**PROPOSED INIS CEALTRA VISITOR
CENTRE TOURISM EXPERIENCE
PROJECT VILLAGE CAR PARK
ENTRANCE JUNCTION ON MAIN
STREET AND VISITOR CENTRE
ENTRANCE JUNCTION ON HARBOUR
ROAD, MOUNTSHANNON, COUNTY
CLARE**

Stage 1 Road Safety Audit

Clare County Council

October 2024

2.2 Comment – Stems of L-Shaped Tactile Paving Not Extended To Back of Footways

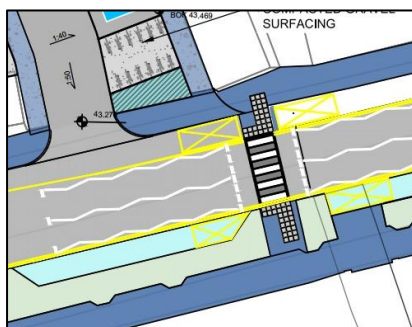
A controlled crossing is proposed on Main Street, immediately east of the proposed Village Car Park entrance junction. The stems of the L-shaped tactile paving on both sides of the crossing are not shown extended to the back of the footways, with reference to the DoT Traffic Management Guidelines. This could reduce awareness of the controlled crossing for visually impaired users, putting them at increased risk of conflicts, trips, falls, collisions and injuries. Although located outside the extent of the entrance junction scheme for audit, it is envisaged that the proposed Village Car Park would increase pedestrian demand at the proposed controlled crossing, potentially increasing the foregoing risks. It is recommended that the stems of the L-shaped tactile paving should be extended to the back of the footways, with reference to the DoT Traffic Management Guidelines, in consultation with Clare County Council.

2.1	Yes	Yes	Tactile paving and drop kerbs will be indicated on the proposed design to facilitate pedestrians. pppropriate	
2.2	Yes	No	Outside scope of this design package. Clare County Council will be notified to advise their public realm designers of this.	Yes

2.3 Problem – Potential Restricted Junction Visibility Splay

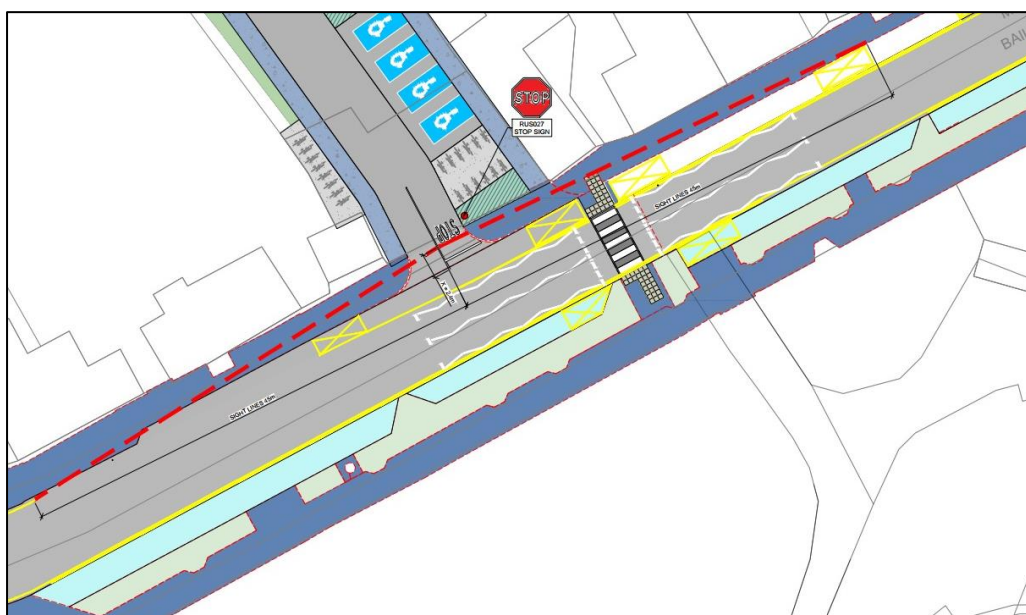
The *Village Car Park Sight Lines* drawing provided for audit shows the proposed entrance junction visibility splays for a distance of 45 metres along Main Street, both east and west of the junction. This is shorter than the 49 metres recommended by DMURS for a 50 km/hour urban design speed, along streets with a bus route. Main Street includes Bus Éireann and TFI Local Link bus routes and stops. The east side entrance junction visibility splay is shown to the nearside of the recessed on-street parking, and not to the nearside of the road traffic carriageway. The entrance junction visibility splays' set-back distance along the centre of the entrance road carriageway is shown from the nearside of the recessed on-street parking, and not from the nearside of the road traffic carriageway.

The proposed entrance junction visibility splays could be restricted by vehicles parked in the recessed on-street car parking spaces provided along the north side of Main Street, including high sided vans. This could increase the risk of exiting vehicles pulling out into the path of vehicles on Main Street, putting them at risk of side impact collisions, material damage and consequent injuries for vehicle occupants. Eastbound vehicles could cross the centre of the Main Street road carriageway to avoid protruding vehicles at the entrance junction, into the path of opposing vehicles, putting them at risk of head on collisions and injuries for vehicle occupants.

It is recommended that clear visibilities should be provided for all locations within the entrance junction visibility splays, for the appropriate Main Street urban design speed, with reference to DMURS, in consultation with Clare County Council.

2.3	Yes	No	Outside scope of this design package. Clare County Council will be recommended to implement the recommendation with their public realm designers.	Yes

2.5 Comment – Potential Restrictions by Tree Planting/Growth

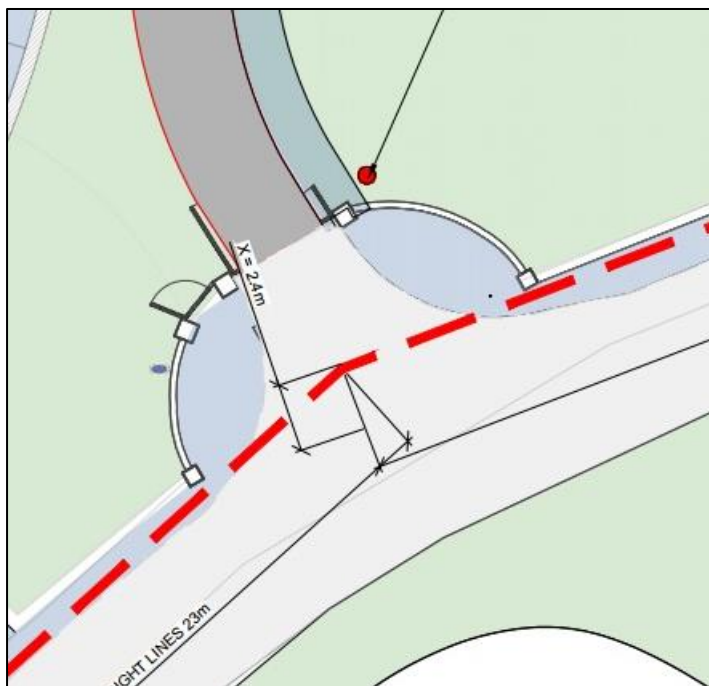
The proposed scheme includes a landscaping design. Tree planting is shown proposed on the immediate east side of the entrance road junction, with a plan extent/overhang shown within the Main Street footway. This could restrict clear widths and heights for pedestrians; and restrict the east side visibility splay of the entrance junction for exiting vehicle drivers. It is recommended that landscaping should be located clear of user facilities and visibilities.

2.4	Yes	Yes	Pertinent drawing will be updated to include the proposed layout being constructed by Clare County Council in the public realm works.	
2.5	Yes	Yes	Landscaping will be adapted to implement the recommendation.

3.2 Problem – Possible Restricted Footway Access and Width

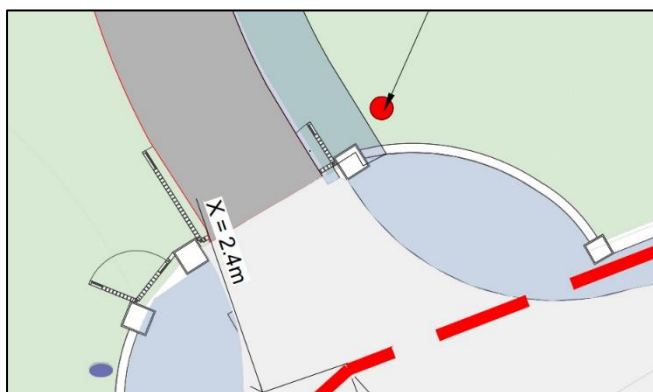
A footway is proposed along the east side of the Visitors Centre access road. The footway tie-in access and width at the entrance junction with Harbour Road are unclear; and may be restricted by the pillar and gate arrangement, and less than the 1.8 metres width identified by DMURS. This could result in possible conflicts for pedestrians, including pedestrians stepping out into the road carriageway, putting them at risk of vehicle collisions and injuries.

It is recommended that appropriate facilities should be provided for pedestrians, with reference to DMURS and the DoT Traffic Management Guidelines.

3.1	Yes	Yes	Tactile paving and drop kerbs will be indicated on the proposed design to facilitate pedestrians.	
3.2	Yes	Yes	A footpath will be added to the north of the pedestrian gate with tactile paving provided to provide pedestrian linkages to the path going north along the east of the driveway to the Rectory.

3.3 Problem – Potential Conflicts for Pedestrians

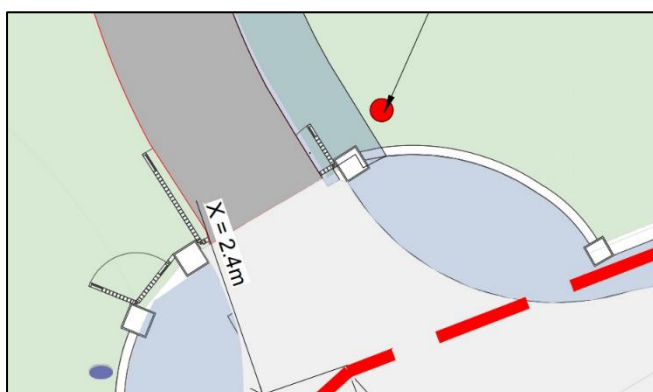
The Old Rectory Interpretive Centre works, under construction during the site inspection, include a new pedestrian gate on the west side of the entrance road, with no internal footway link proposed as part of the Old Rectory Interpretive Centre works, or as part of the proposed Visitor Centre and entrance junction. Pedestrians using the west side pedestrian gate could cross the entrance road, to use the east side footway, immediately north (inside) the gated pillared entrance; and inbound (northbound) vehicle drivers may not have adequate visibilities to them, putting pedestrians at risk of vehicle impacts and injuries. Mobility and visually impaired users could be at risk of trips, falls and injuries by a lack of appropriate facilities.

It is recommended that appropriate facilities should be provided for pedestrians, with reference to DMURS and the DoT Traffic Management Guidelines.

3.3	Yes	Yes	A footpath will be added to the north of the pedestrian gate with tactile paving provided to provide pedestrian linkages to the path going north along the east of the driveway to the Rectory.

3.4 Problem – Potential Excessive Vehicle Speeds

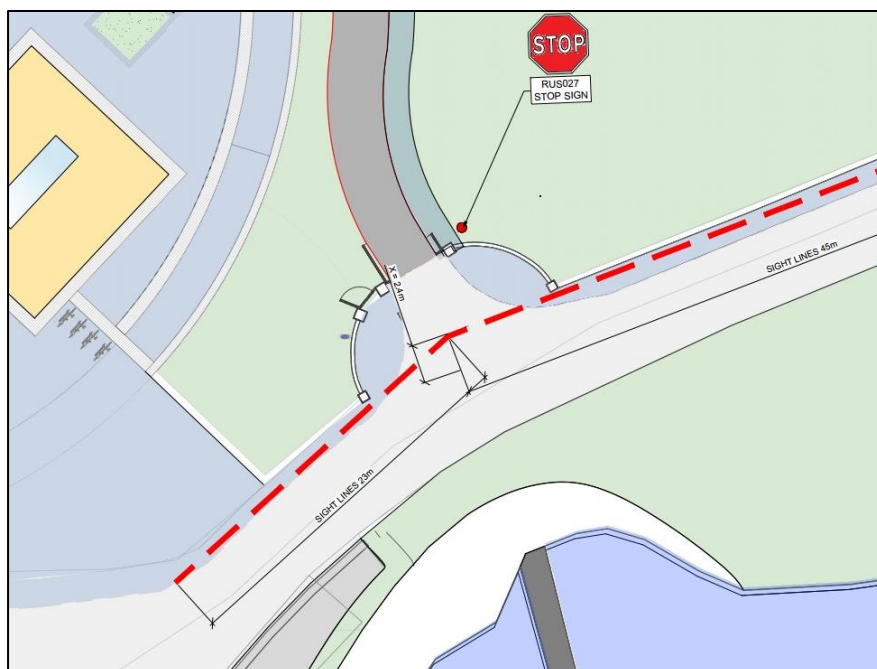
The *Harbour Sight Lines* drawing provided for audit for the proposed Visitor Centre entrance junction shows a proposed entrance junction west side visibility splays for a distance of 23 metres along Harbour Road, consistent with DMURS for a 30 km/hour urban design speed. During the site inspection, the existing speed limit was 50 km/hour. The *Civil Utilities Planning Report* provided for this audit indicates that the speed limit will be reduced. The proposed new speed limit is unclear. Excessive vehicle speeds, including up to 50 km/hour, could increase the risk and severity of potential collisions and injuries involving vehicles and pedestrians using the proposed entrance junction.

It is recommended that an appropriate speed limit should be provided, with reference to DMURS and the DoT Traffic Signs Manual, with commensurate stopping sight distances and visibility splays for the proposed entrance junction.

3.4	Yes	Yes	A 30km/hr share surface is proposed in the Harbour Carpark and speed limit signage will be erected to that effect.
